| | STANDARD DESIGN - 44' ROADWAY, 3 SPAN BRIDGES CONTINUOUS CONCRETE SLAB BRIDGES NOVEMBER, 2006 | |
| | ABUTMENT DETAILS 0° SKEW - TIMBER PILING | J44-31-06 |

PILE PLAN - 0° SKEW
WOOD PILING

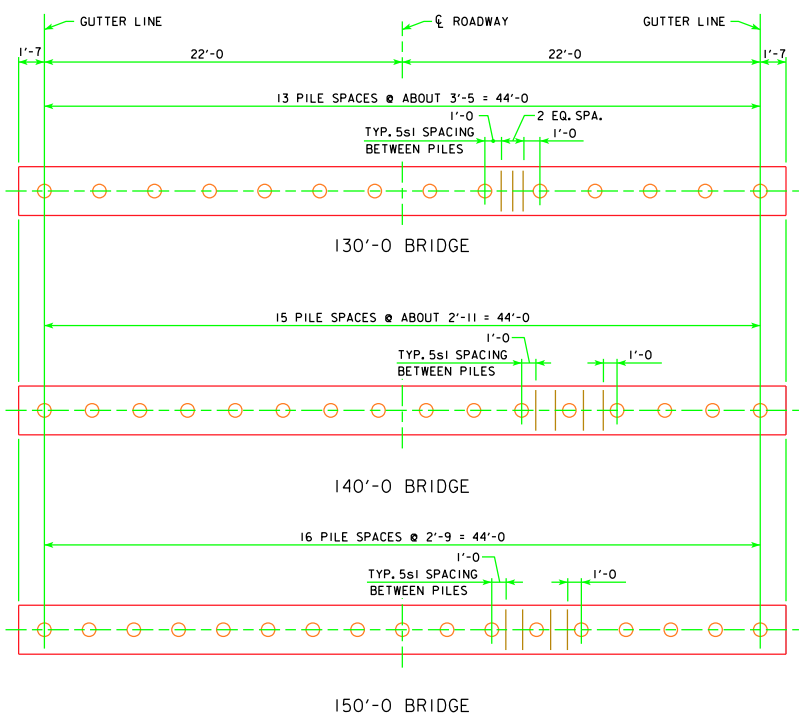
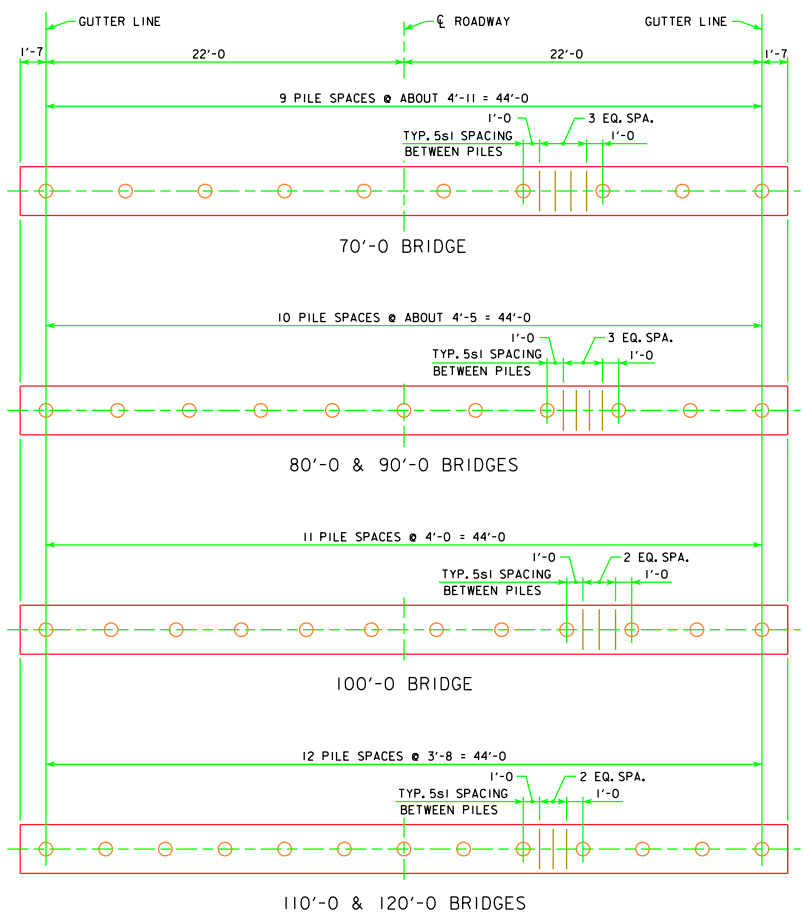
REVISED 11-08 - REVISED NUMBER OF PILES FOR 80'-0 AND 110'-0 BRIDGES.
